Gillig Campaign ID Number: 07V-057

*Gillig has decided that a defect **which** relates to motor vehicle safety exists in some buses equipped with certain Lift-U wheelchair **lifts** manufactured between 1987 and 1996.*

### **Lift U Recall 07V-057**

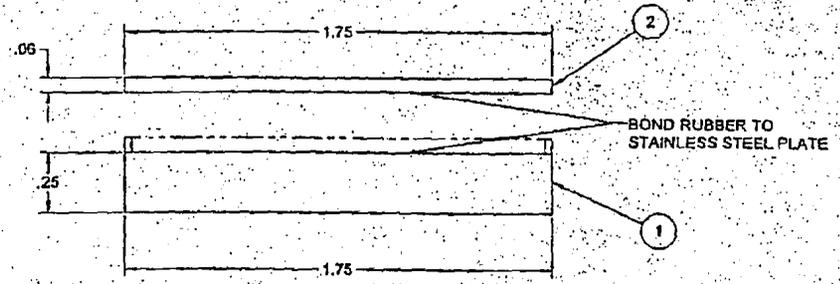
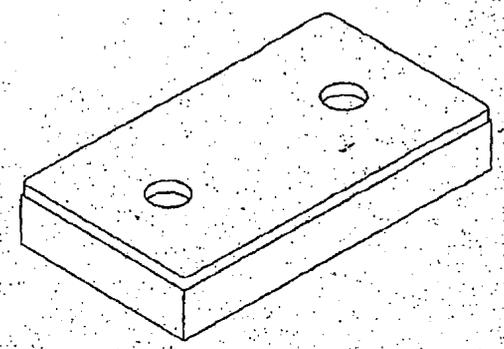
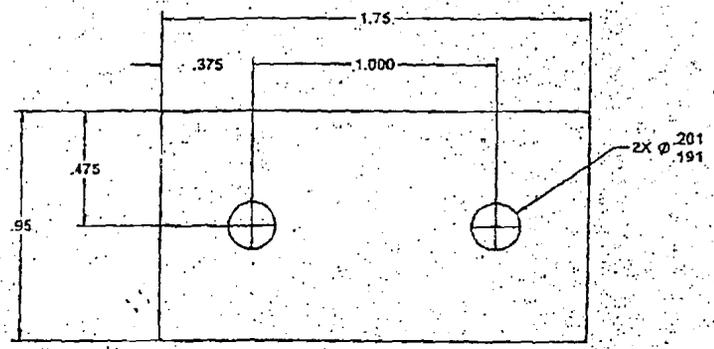
- 1. Review the attached list of **VIN's** provided (if any), **If** your buses still have to original equipment lifts installed with solid bar linkage, you should contact Lift-U to get a closeout plate, Lift-U Part # 123-1029; a closeout assembly, Lift-U Part # **123-1032**; drill template, Lift-U Part # 524-0197 and rivets along with installation instructions for these parts.*
- 2. **Install** the parts as instructed on Lift-U drawing # 123-1033. Return a copy of the enclosed "Recall Sheet" noting when the installation of parts was completed.*
- 3. Federal regulations require that any vehicle lessor receiving this recall notice must forward a copy of this notice to the lessee within ten days.*
- 4. **If** you have already performed this repair, you may be eligible to receive reimbursement for*

REVISIONS							
LTR	ECO	APPD	DATE	DESCRIPTION	DPFR	DATE	CHGFR
A				RELEASED	DPJ	08/25/2003	
B				INCREASED OPENING BY .18"	DPJ	07/13/2006	6/13/06

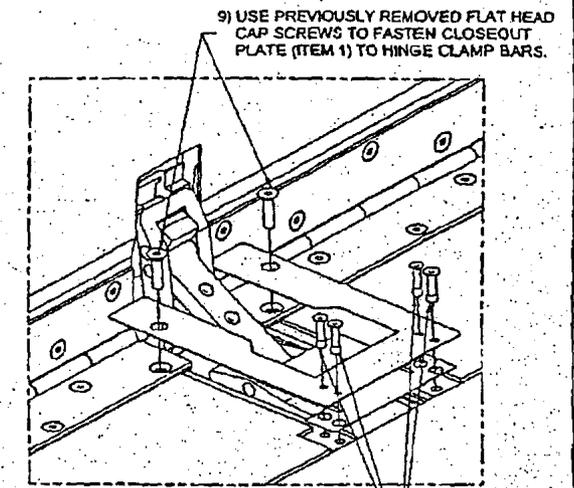
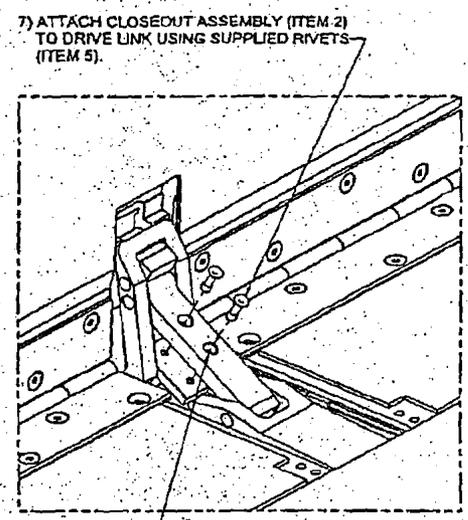
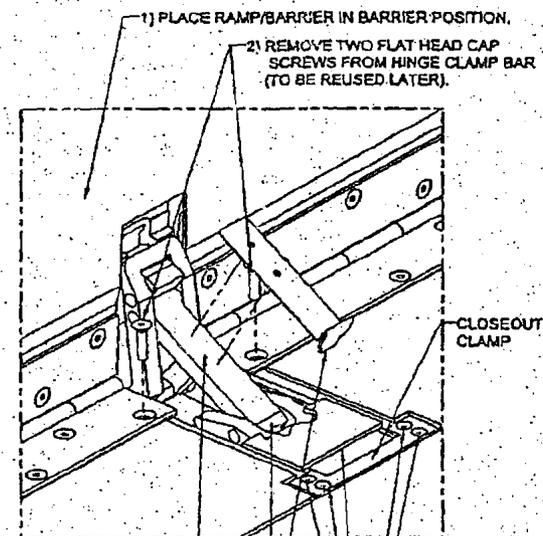
REVISIONS									
LTR	ECO	APPD	DATE	DESCRIPTION	OPTR	DATE	CHKD	DATE	
A				RELEASED.	DPJ	11/20/2008			
B				ADDED FLANGE PROFILE	DPJ	01/13/2009			4/13/09
